ZF Aftermarket Service Information

Oil pan part number change 8HP automatic transmission

Validity	From production date 2020-08-05
Distribution list	Aftermarket
Document number	SI2021_001_SBR_EN

Fig. 1

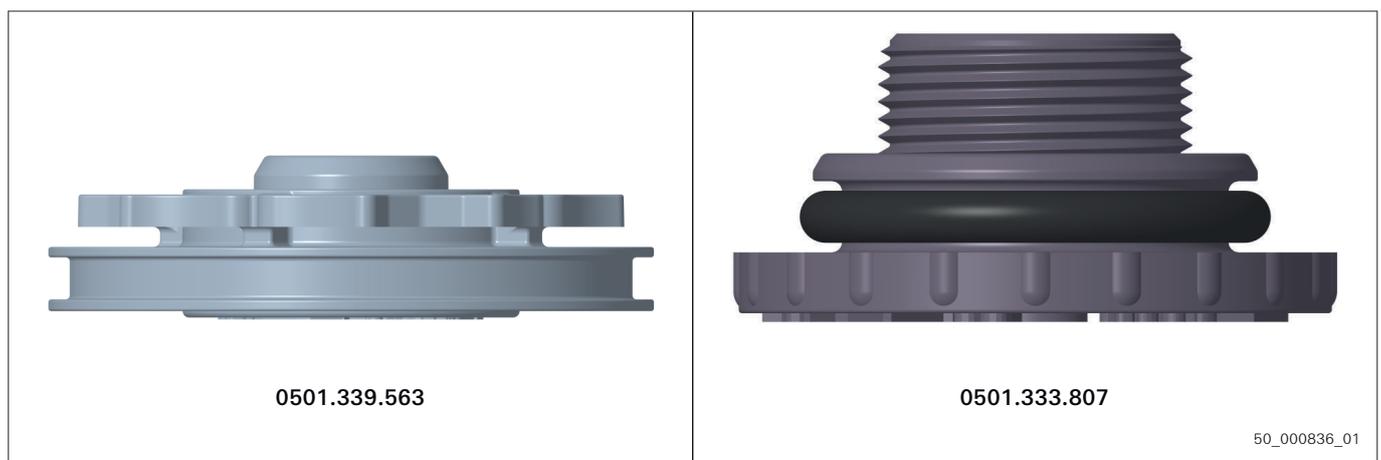
The oil pan **0501.220.614** will be replaced **from production date 2020-08-05**. The new oil pan is manufactured by 2 suppliers in parallel and has its own, distinct part number for each supplier. For use in standard transmissions, see **Tables 4 and 5**.

When replacing the complete oil pan, both new part numbers can be used as replacements for 0501.220.614.

When replacing individual parts, the following differences should be noted:

- The oil drain plug of oil pan 0501.226.590 can be exchanged with the oil drain plug of oil pan 0501.220.614. The oil drain plug of oil pan 0501.226.591 only fits oil pans with the same part number. See also **Table 6**.
- The oil pan seal always only fits one oil pan. See also **Table 6**.
- When ordering individual parts, always provide the part number of the installed oil pan. Alternatively, you can state the required part number of the oil drain plug or the oil pan seal. Please also refer to **Table 6** and **Figures 1-5**.

As **spare part**, the new oil pan will be delivered with part number **0501.226.590 (IBS Filtran company)** or with part number **0501.226.591 (Hengst company)**, depending on the stock.
